RQX 6-Series and 7-Series Callbox Modification for Normally Closed Relay Switch

UPDATE - INSTRUCTIONS FOR PCB 1750370J and later, 1750380K and later

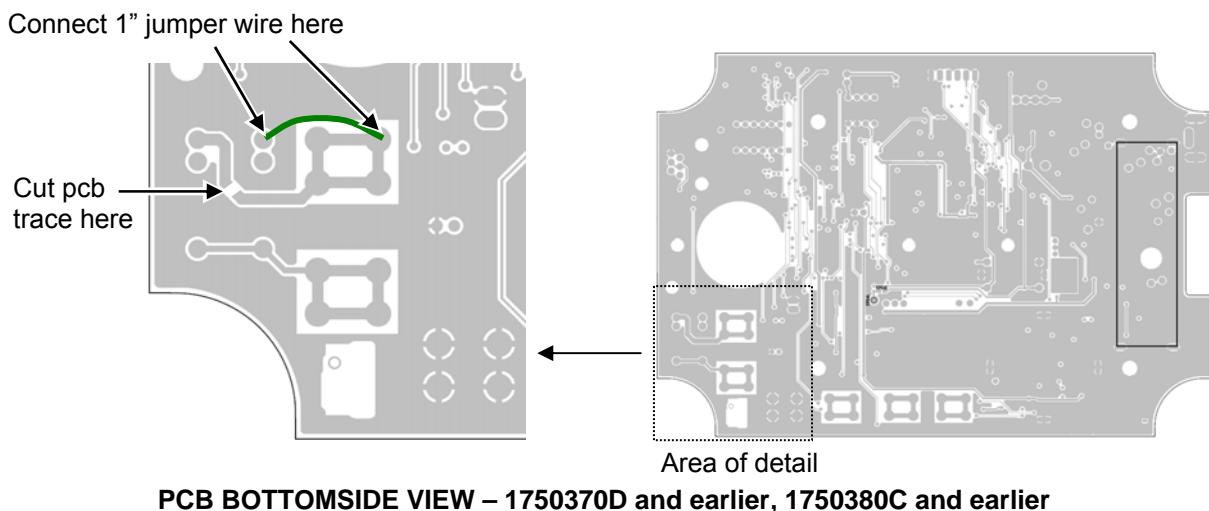
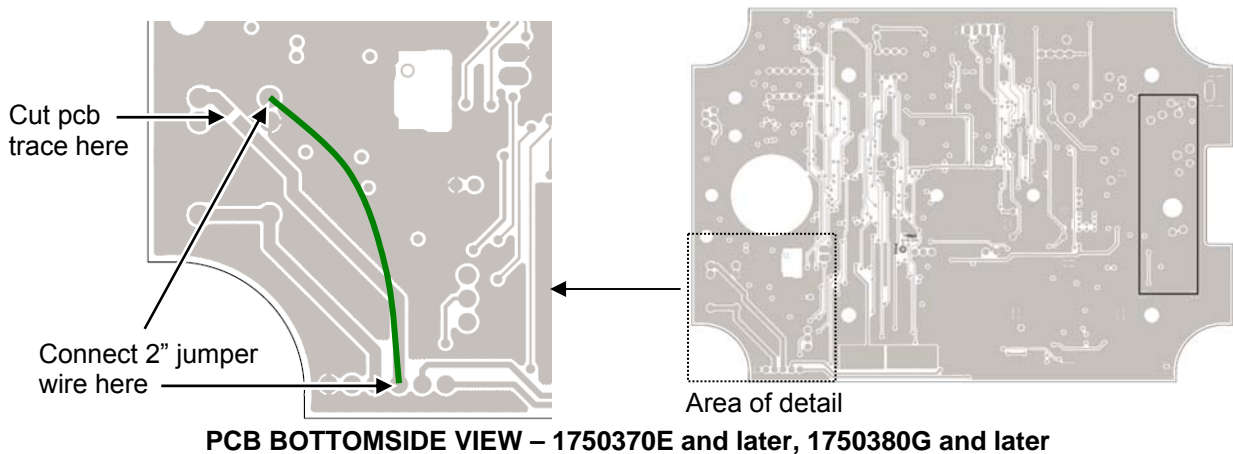
RQX PCB revisions 1750370J or 1750380K and later provide the ability to be switched from the standard normally-open switch contact to a normally-closed switch contact by moving R555 (0 Ω) from one set of PCB solder pads to another as shown below.

As an alternative, you can employ the cut and wire modification on the PCB bottomside as shown below.

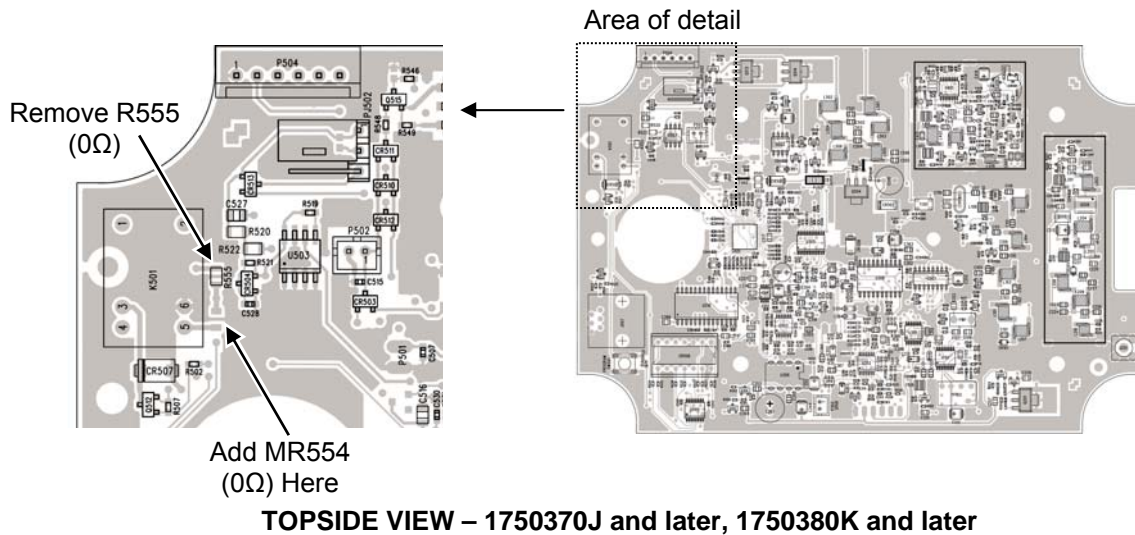
The callbox can be modified per the following instructions to reverse the relay switch operation. The RQX will now provide a normally-closed switch contact, with the relay switch opening only when the programmed conditions are met.

1. Carefully remove the PCB assembly per the instructions in the RQX Maintenance and Repair Manual (RQX-MRM-e).
2. Identify the PCB revision and refer to the correct illustration below.
3. Cut the PCB trace as indicated below to disconnect the normally open relay contact.
4. Solder a 2" length of #24 AWG stranded wire as indicated below to connect the normally closed relay contact. Note: Older PCB revisions require a 1" length of wire.
5. Reassembly the unit per the RQX Maintenance and Repair Manual (RQX-MRM-e).
